# CITY OF STAR

## LAND USE STAFF REPORT

**FILE(S) #:** FP-24-01, Final Plat, Trident Ridge Subdivision Phase 8

CONSTRUCTION DRAWINGS FOR:  
**TRIDENT RIDGE SUBD. NO. 8**  
 LANDSCAPE MATERIALS AND LAYOUT PLAN

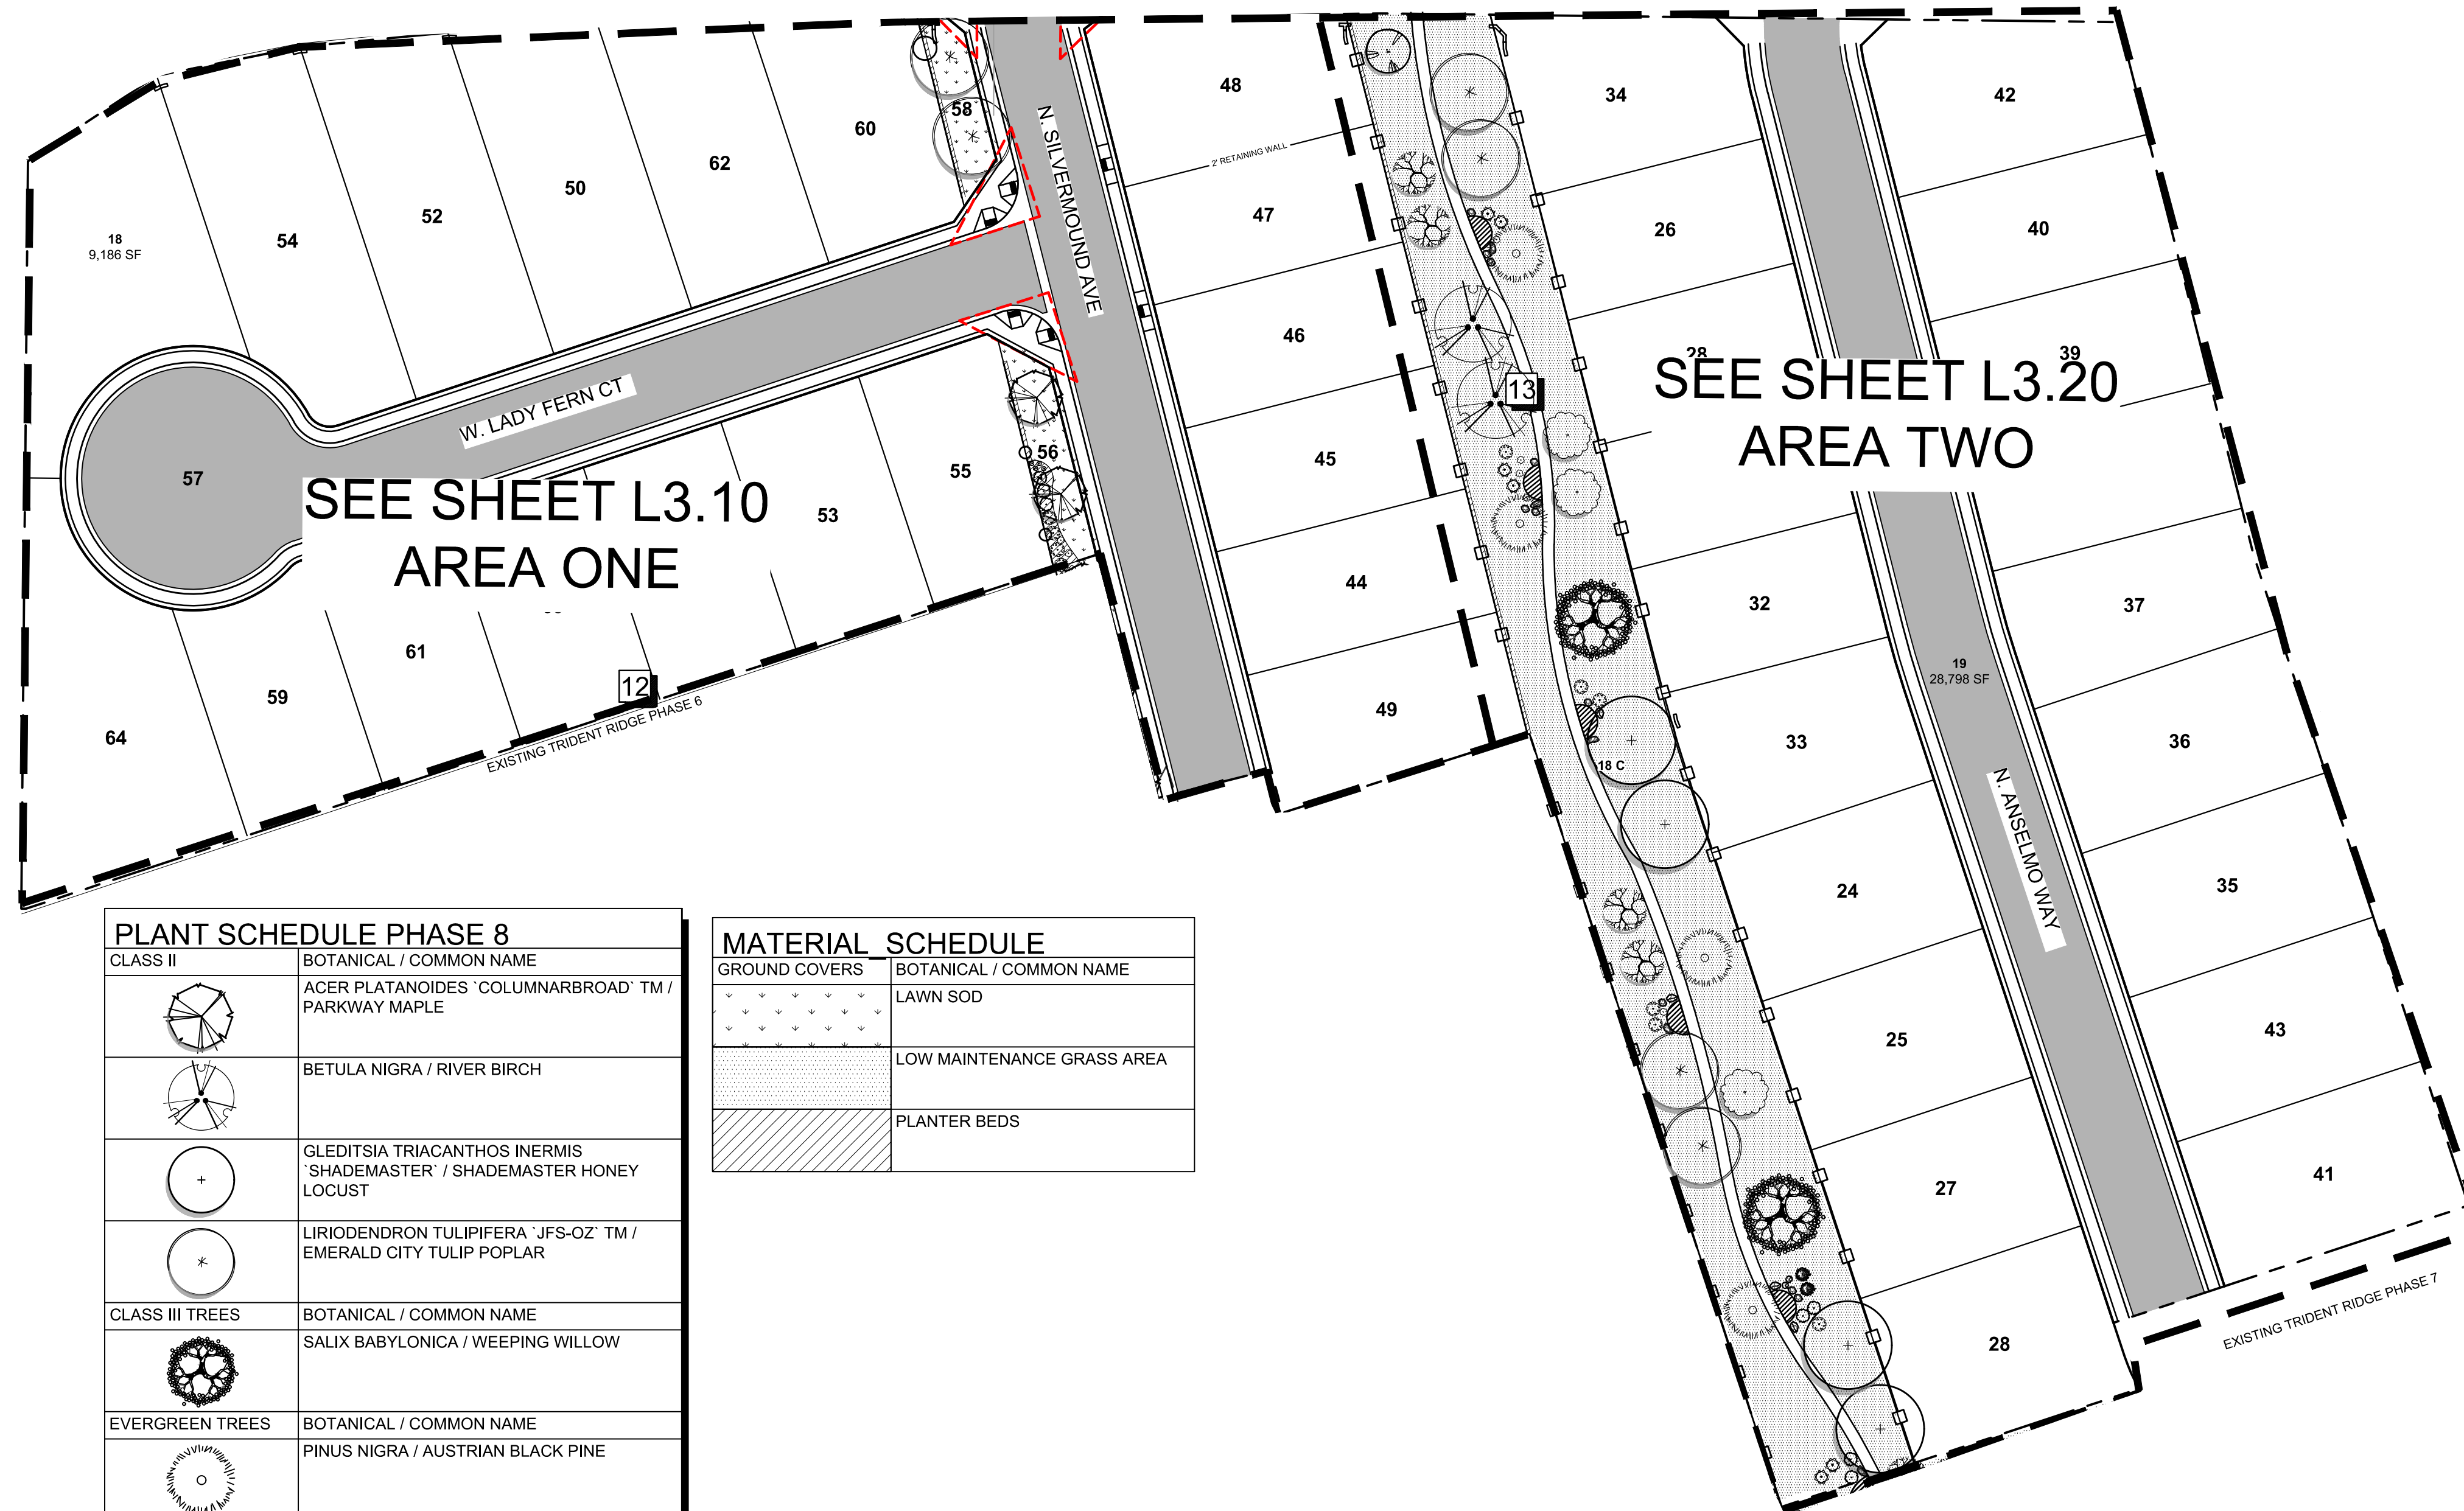
The landscape plan submitted was approved as far as the locations. However, the UDC, Chapter 4, Section B-7 C-3 Street Trees, states that a minimum density of one (1) tree per thirty-five (35) linear feet is required. This can be accomplished with the requirement of having trees installed in the front yards of each lot.

**Landscaping:** As required by the Unified Development Code, Chapter 8, Section 8-8C-2-M (2) Street Trees; A minimum of one street tree shall be planted for every thirty-five (35) linear feet of street frontage. The applicant shall use "Treasure Valley Tree Selection Guide", as adopted by the Unified Development Code. Section 8-8C-2, J5 states that a minimum of one deciduous shade tree per four thousand (4,000) square feet of common area shall be provided. **The submitted landscape plan appears to satisfy these requirements.**
